## **NSW Roads and Maritime Services**

# **WOOLGOOLGA TO BALLINA | PACIFIC HIGHWAY UPGRADE SUBMISSIONS / PREFERRED INFRASTRUCTURE REPORT**

Chapter 4

November 2013

**Figure 4-35: Additional borrow sites**

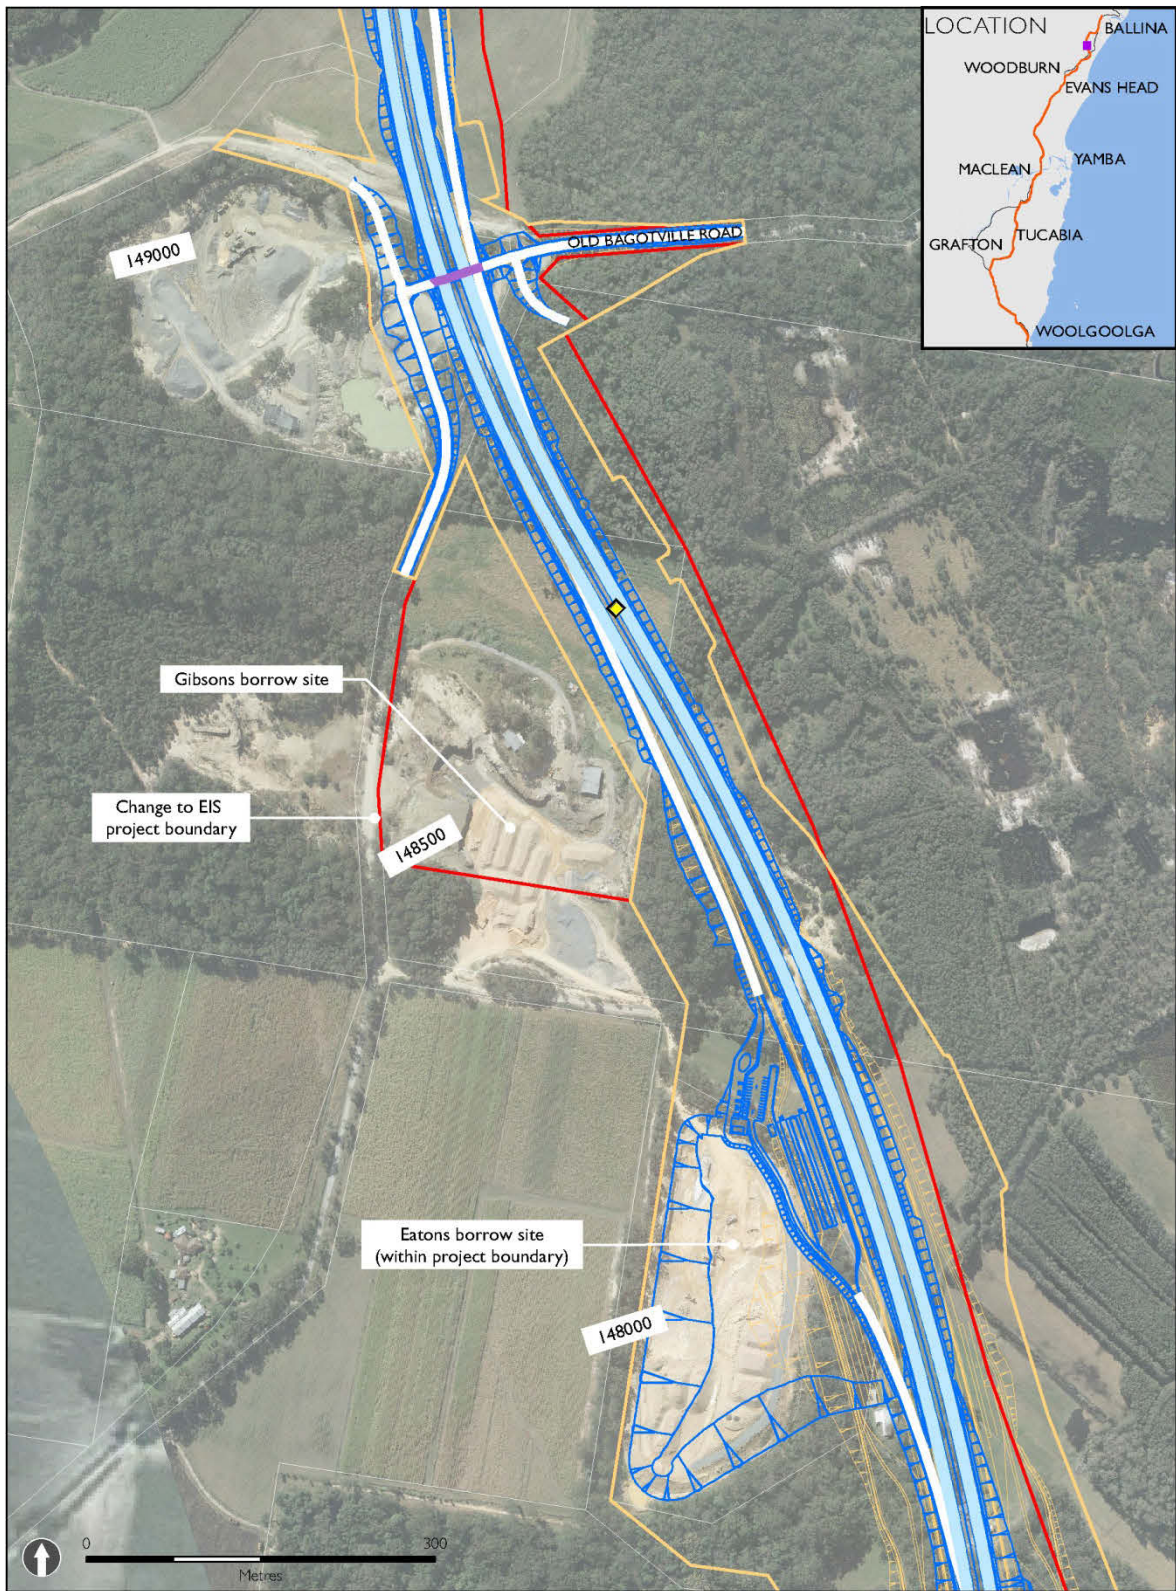
The design refinement shown in Figure 4-35 includes:

- Extraction of the material from the borrow sites via conventional excavation, ripping or hard ripping. There may be a need to use some form of blasting, but this would only occur where alternative extraction methods are not practical.

- Material processing, such as crushing and screening.
- Site rehabilitation, using available surplus material to re-contour the sites, mimicking the existing landform. The final landform would then be landscaped to a rural setting, using native vegetation to improve fauna connectivity.

The inclusion of these borrow sites within the project would provide up to a 557,000 cubic metres of material that would otherwise be sourced from commercial quarry sites. These sites would reduce the need for importing earthworks materials from commercial sources and would minimise the need to haul imported material through the residential streets of Wardell.

Figure 4-36: Revised excavation design at the borrow source west of Wardell

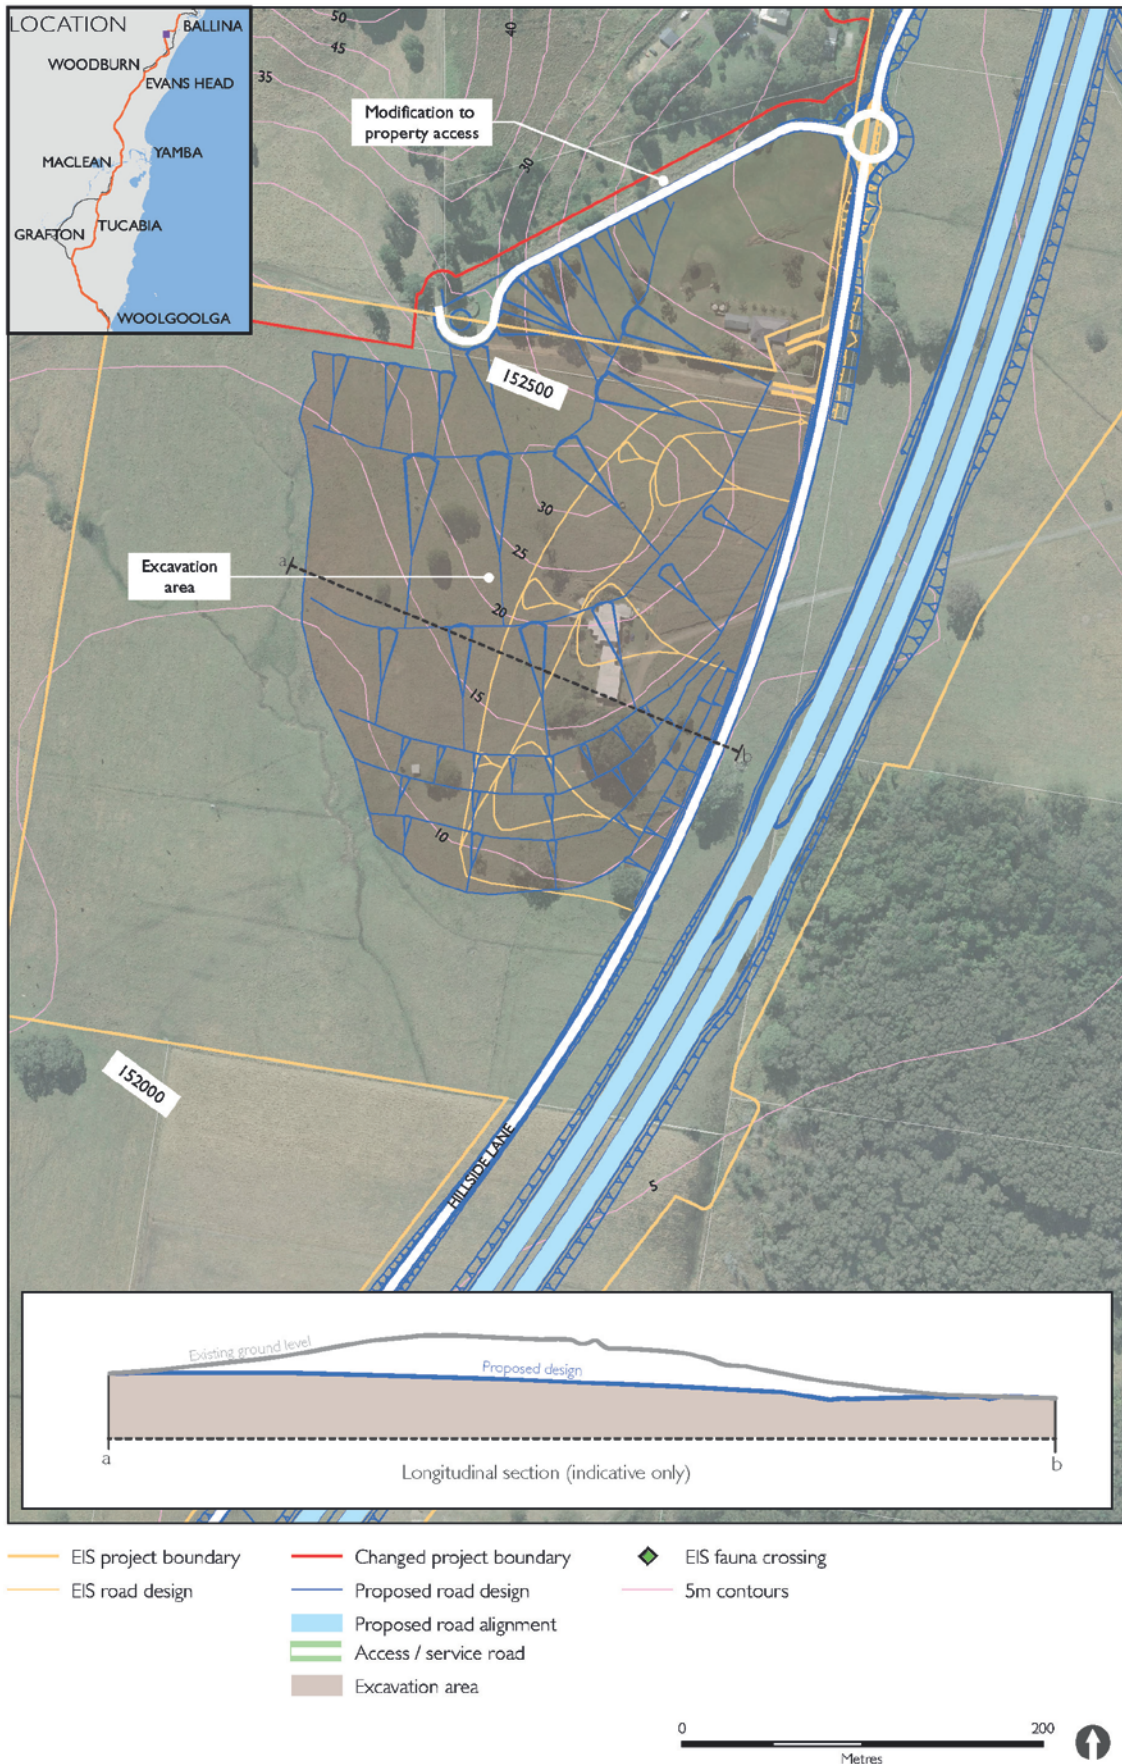
The design refinement is shown in Figure 4-36.
